Lot #2 Weber Mesa Baggs Wyoming

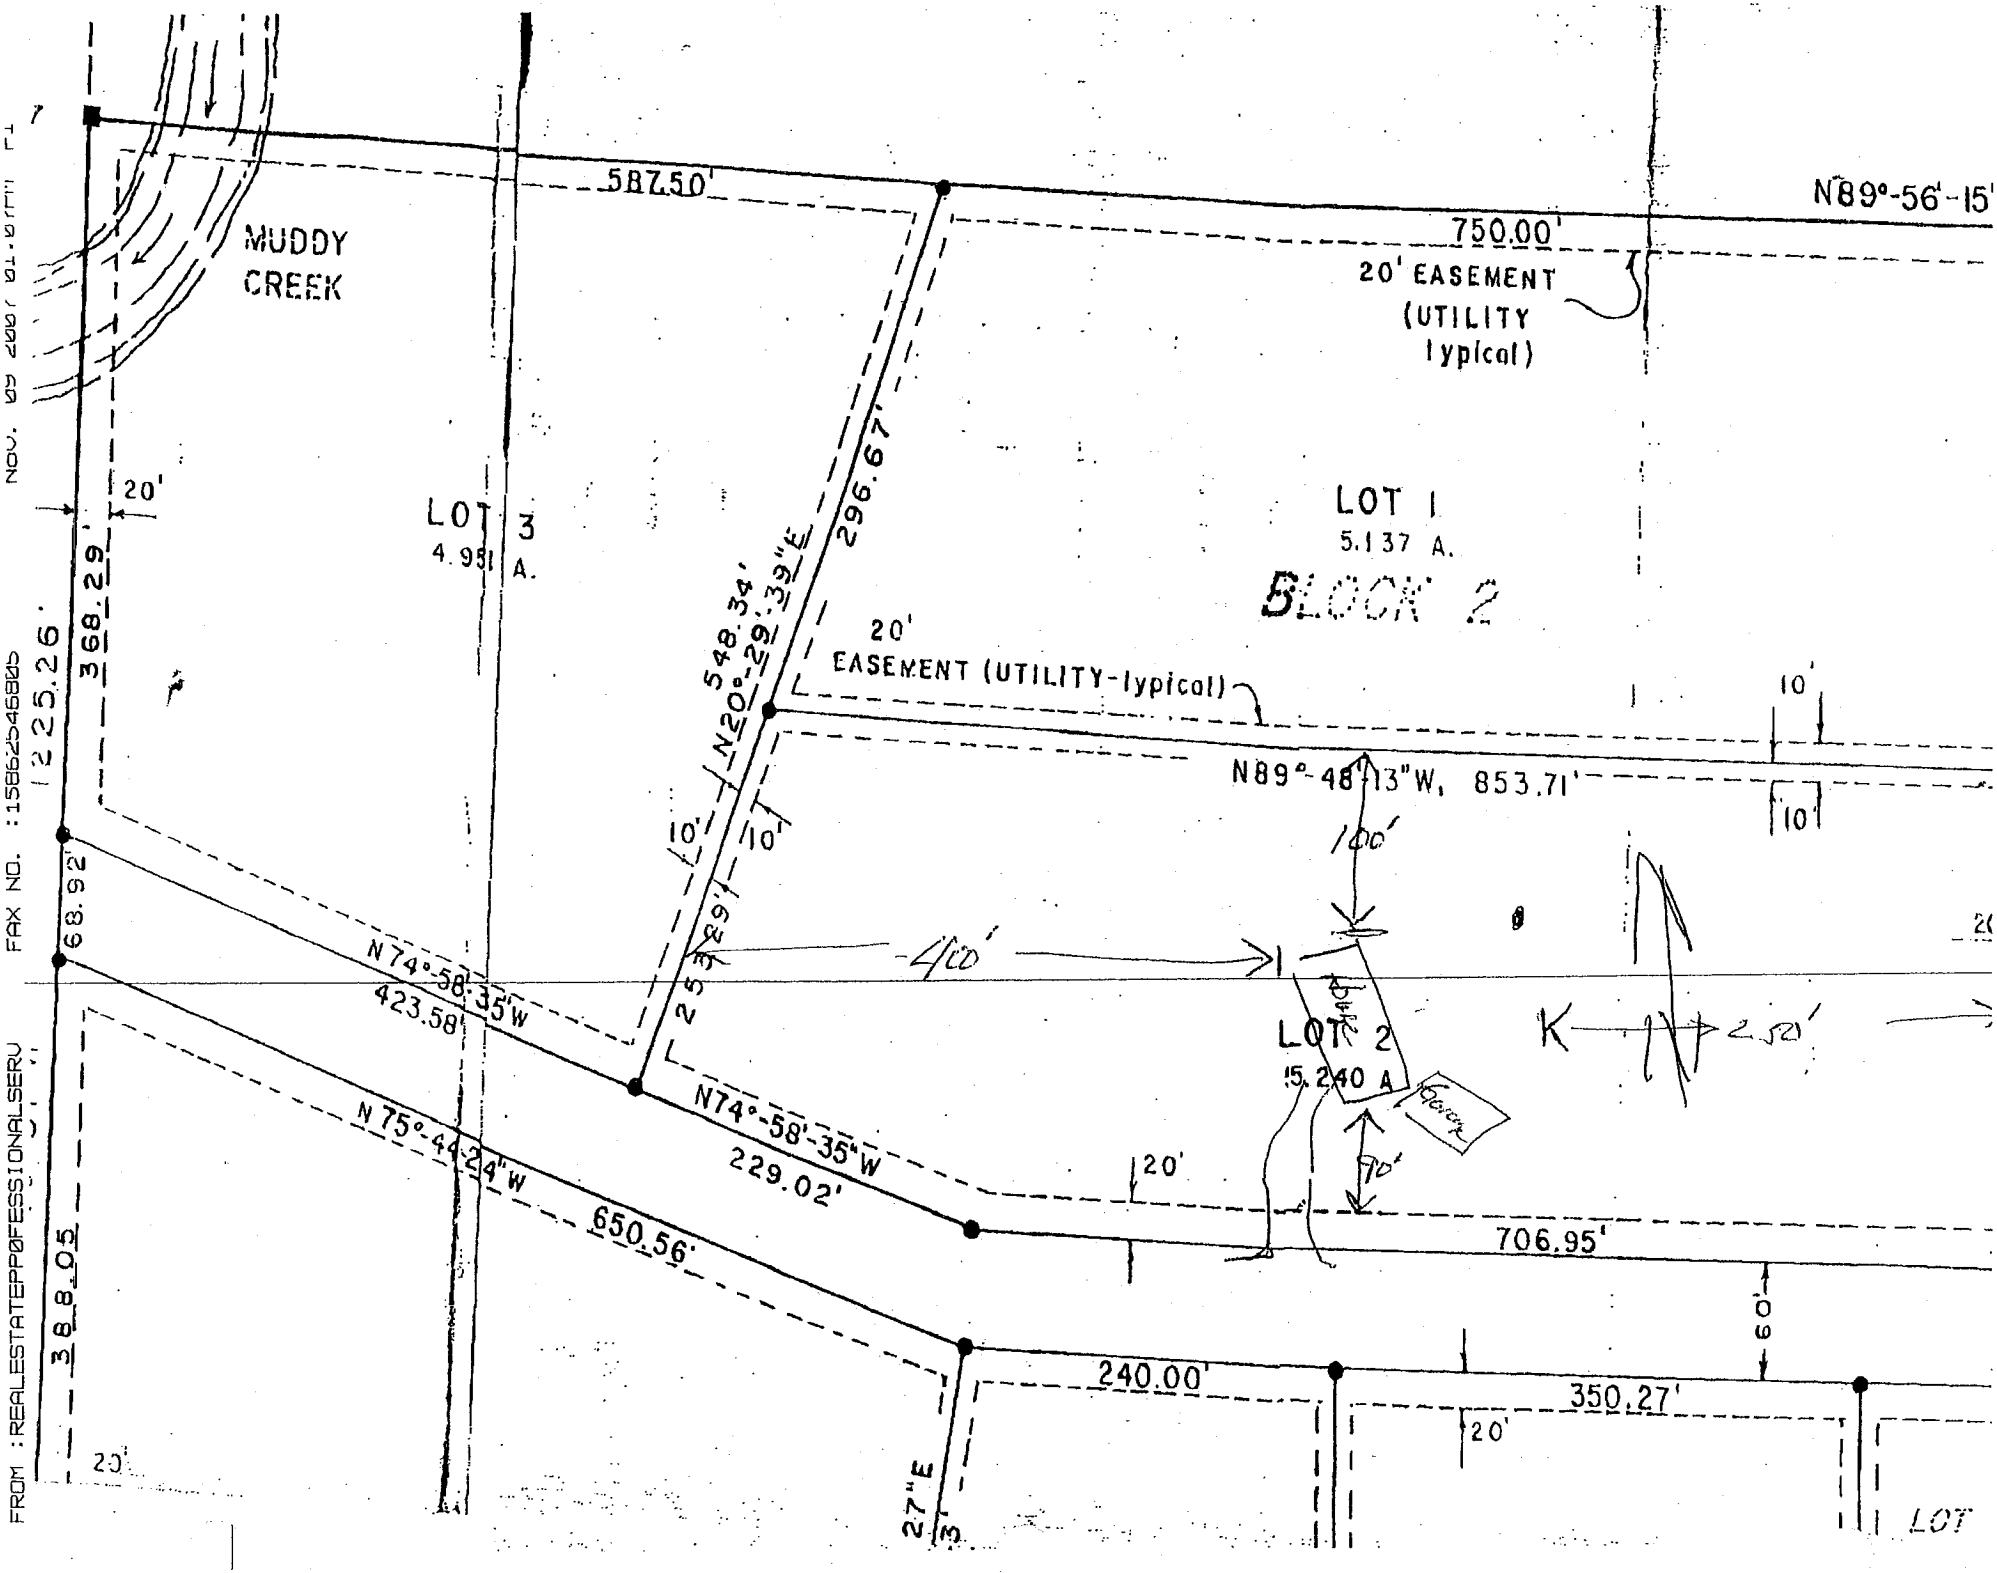
5. Leachfield and Septic Tank Will NOT Fit on the Property as Laid Out - the site plan submitted has the proposed septic tank location and leachfield running almost due north from the north side of the house. According to the information submitted the lot is only 258 feet wide in the north/south direction, and 30 feet of that is unusable because it is utility easement. This leaves only 228 feet of useable space. According to site information submitted, the south side of the house is about 90 ft north of the south utility easement line. Estimate the house is at least 40 ft long.

The plans show 20 ft from the north side of the house to the septic tank, septic tanks are at least 10 ft long, and then another 10 ft to the head of the leach field. Including that the leachfield must stay at least 10 ft away from the north utility easement line, the total north/south footage taken up by these items is 180 feet. This leaves only (228 – 180 =) 48 feet to construct the leachfield lines in. The length of the submitted trenches (22 units), which was 33% too short, was at least 88 feet. The corrected length of the trenches would be 132+ feet in two trenches (which will not be allowed), or 68+ feet in four trenches. Even the four trench arrangement is 20 feet longer than what is available if everything is laid out straight north and south. Therefore:

> A leachfield configuration and layout that actually fits on this lot must be laid out on the site plan with dimensions and distances that actually add up and fit within the dimensions of the lot.
